SUBJECT: REPLACEMENT OPTION for product originally using 23-66-0255 Switch and a one piece Molded Strain Relief Cord 22-64-0075, 22-64-0076 or 22-64-0080

23-66-0255 is obsolete and replaced by 14-46-1852 Service Instruction Notice —

DATE: March, 2013

TOP ILLUSTRATION SHOWS THE WIRE ROUTING FOR OOLS WITH CURVED HANDLES (OLD DESIGN), NOTE: AFTER FIELD IS INSTALLED, CUT WIRE NO. 5 TO 4" FROM REAR OF MOTOR HOUSING.

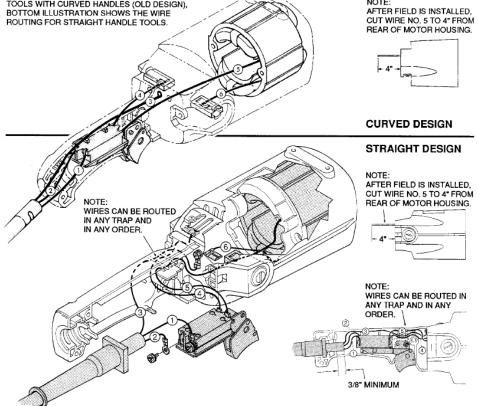
In above 'AFFECTED' product using a one piece Molded Strain Relief Cord 22-64-0075, 22-64-0076 or 22-64-0080, to use 23-66-1802 Handle / Switch Service Kit as a replacement for 23-66-0255 Switch – will require a 22-64-3000 Cordset & separate Strain Relief 44-76-0170 and in addition, 3ea - 06-82-2378 10-24X1 SLT PN MACH TORX HANDLE SCREWS and 3ea 06-55-1050 10-24 HEX NUTS - if the cordset on the tool is good, simply cut the molded strain relief off of the cord and establish new lead lengths, without having to purchase/use a 22-64-3000 cord; then using the 44-76-0170 strain relief properly secure the cord and strain relief into the handles supplied with the 23-66-1802 switch / handle kit - see Wiring Instructions 58-01-0371 – some rewiring as lead lengths can change, will need to be done.

*Note: 6095, 6096 and 6098 use a Power & Control Module - Power & Control Modules can be removed and tool wired to 58-01-0371 Wiring Instruction - some rewiring will be need to be done, with the connector blocks/modules discarded.
